# HISTORIC AND DESIGN REVIEW COMMISSION

June 29, 2022

**HDRC CASE NO:** 2022-352  
**ADDRESS:** 609 HAYS ST  
**LEGAL DESCRIPTION:** NCB 530 BLK 14 A5 EXC NW IRR 34.88 FT BY 68 FT  
**ZONING:** R-5, H  
**CITY COUNCIL DIST.:** 2  
**DISTRICT:** Dignowity Hill Historic District  
**APPLICANT:** Allison Hu/BRADSHAW NICHOLAS & ALLISON MAY HU  
**OWNER:** Allison Hu/BRADSHAW NICHOLAS & ALLISON MAY HU  
**TYPE OF WORK:** Exterior modifications, site work, fencing, porch construction, porch modifications, rehabilitation

### ROOF PLAN

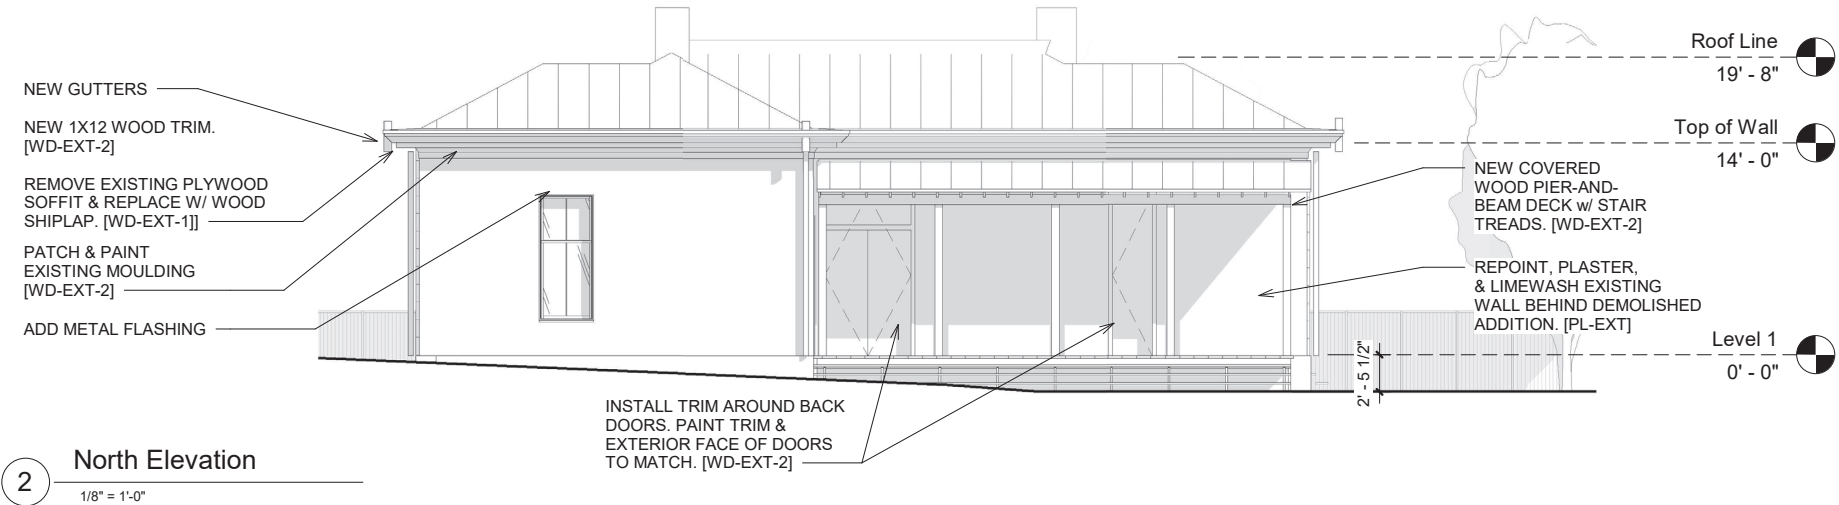
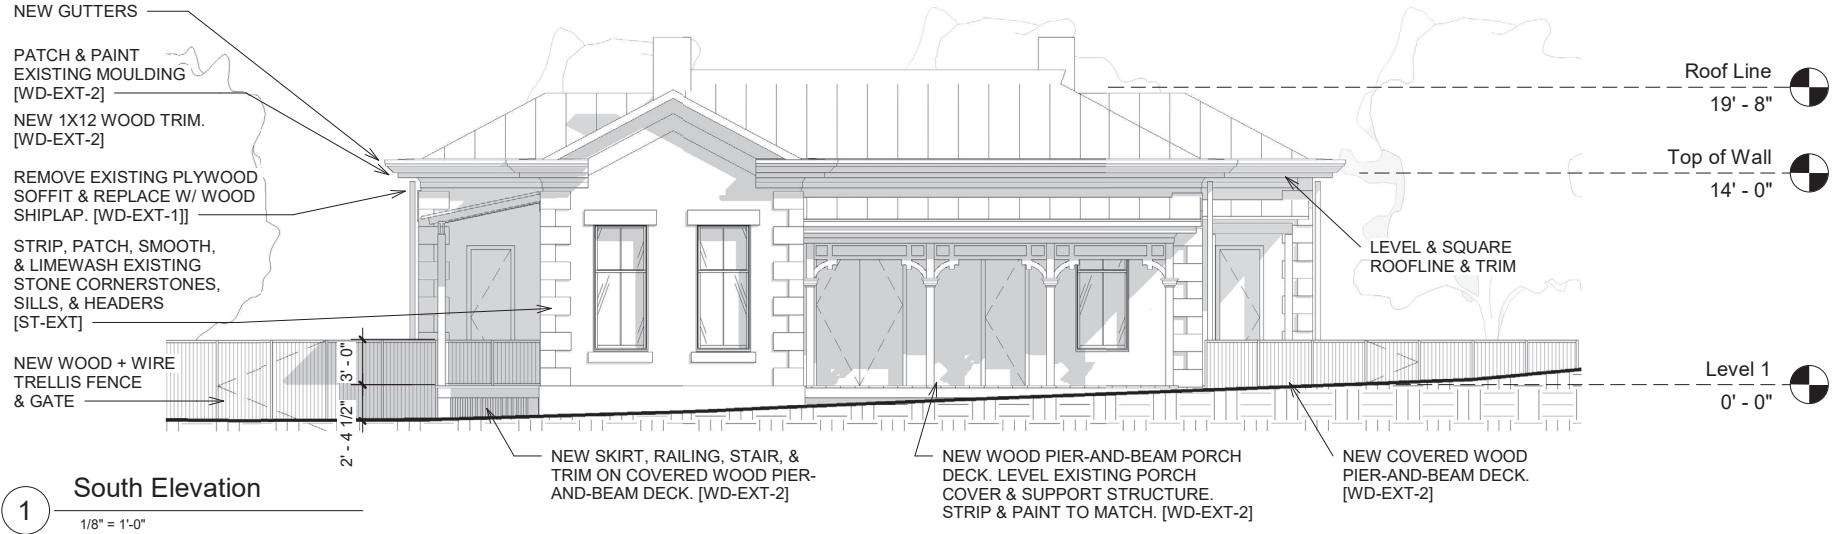
- b. REHABILITATION – The applicant has proposed to perform rehabilitative scopes of work to the historic structure that include repairing the existing wood soffit, fascia, and moulding, and painting. The applicant has also proposed to install new metal gutters. Staff finds the proposed repair work to be appropriate; however, staff finds that wood should be repaired with period appropriate profiles. Cedar shiplap would not have been installed historically as soffit material. Additionally, staff finds that the proposed gutters should be submitted for review and approval.

1. Staff recommends approval of item #1, based on finding b with the following stipulations:
  - i. That the applicant submit gutter details to OHP staff for review and approval.

- ii. That wood feature period appropriate profiles. Cedar should be eliminated for a period appropriate soffit profile.
2. Staff recommends approval of item #2, the demolition of the non-contributing 1980's addition based on finding c.

### NORTH & SOUTH ELEVATIONS

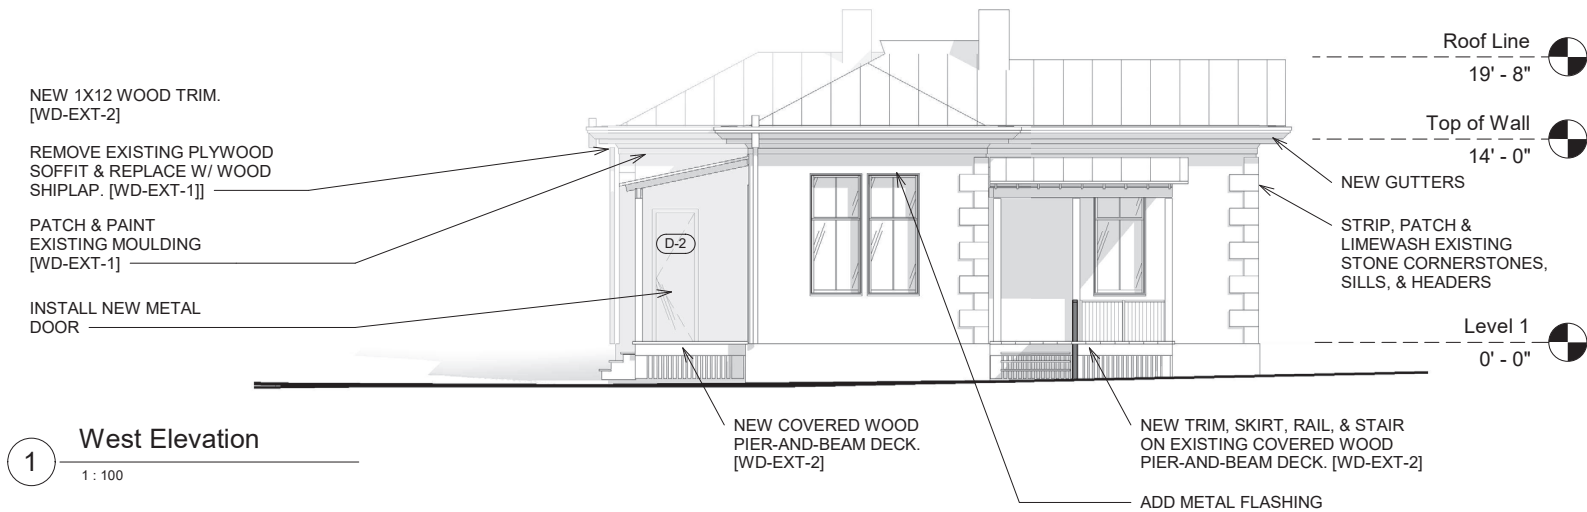
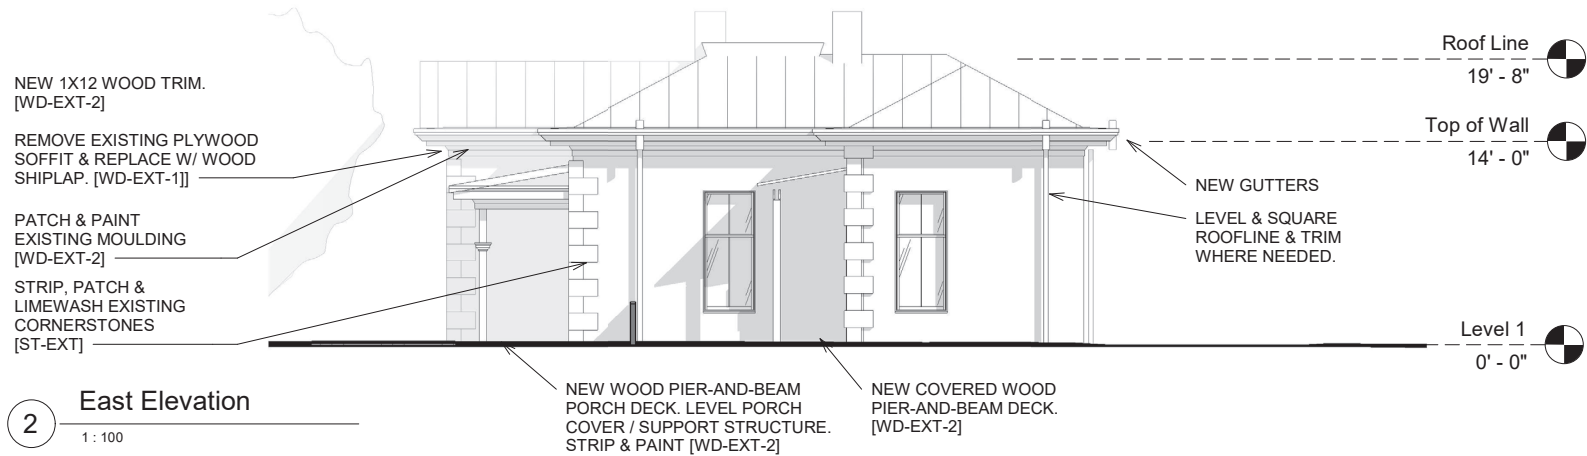
- d. FRONT PORCH – The applicant has proposed to perform rehabilitative scopes of work to the front porch including the installation of a new pier and beam deck above the existing concrete porch structure, and the installation of deck boards. The applicant has also proposed to level the non-original concrete porch. Generally, staff finds the proposed scope of work to be appropriate; however, staff finds that the proposed replacement porch decking should feature 1x3 tongue and groove decking, installed perpendicular to the front façade. Standing seam metal roofs should feature smooth panels that are 18 to 21 inches wide, seams that are 1 to 2 inches in height, a crimped ridge seam and standard galvalume finish.

- f. REAR PORCH – The applicant has proposed to construct a new rear porch to feature a footprint of 256 square feet. The proposed porch will be constructed of wood with a pier and beam foundation, wood decking, skirting and stairs. The porch roof will be standing seam metal. Staff finds the proposed construction of the rear porch to be appropriate and consistent with the Guidelines; however, staff finds that columns should be six inches square with capital and base trim. Staff finds that the proposed porch decking should feature 1x3 tongue and groove decking, installed perpendicular to the rear façade. Standing seam metal roofs should feature smooth panels that are 18 to 21 inches wide, seams that are 1 to 2 inches in height, a crimped ridge seam and standard galvalume finish.

3. Staff recommends approval of item #3, rehabilitative scopes of work to the front porch based on finding d with the following stipulations:
  - i. That the proposed porch decking feature 1x3 tongue and groove decking, installed perpendicular to the front façade.

- ii. That standing seam metal roofs should feature smooth panels that are 18 to 21 inches wide, seams that are 1 to 2 inches in height, a crimped ridge seam and standard galvalume finish.

5. Staff recommend approval of item #5, the construction of a rear porch based on finding f with the following stipulations:
  - i. That the applicant submit a porch railing detail and a section noting column dimensions, beam dimensions and soffit and fascia profiles.

- ii. That columns feature six inches square with capital and base trim and chamfered corners.
  - iii. That the proposed porch decking feature 1x3 tongue and groove decking, installed perpendicular to the front façade.

- iv. That standing seam metal roofs should feature smooth panels that are 18 to 21 inches wide, seams that are 1 to 2 inches in height, a crimped ridge seam and standard galvalume finish.
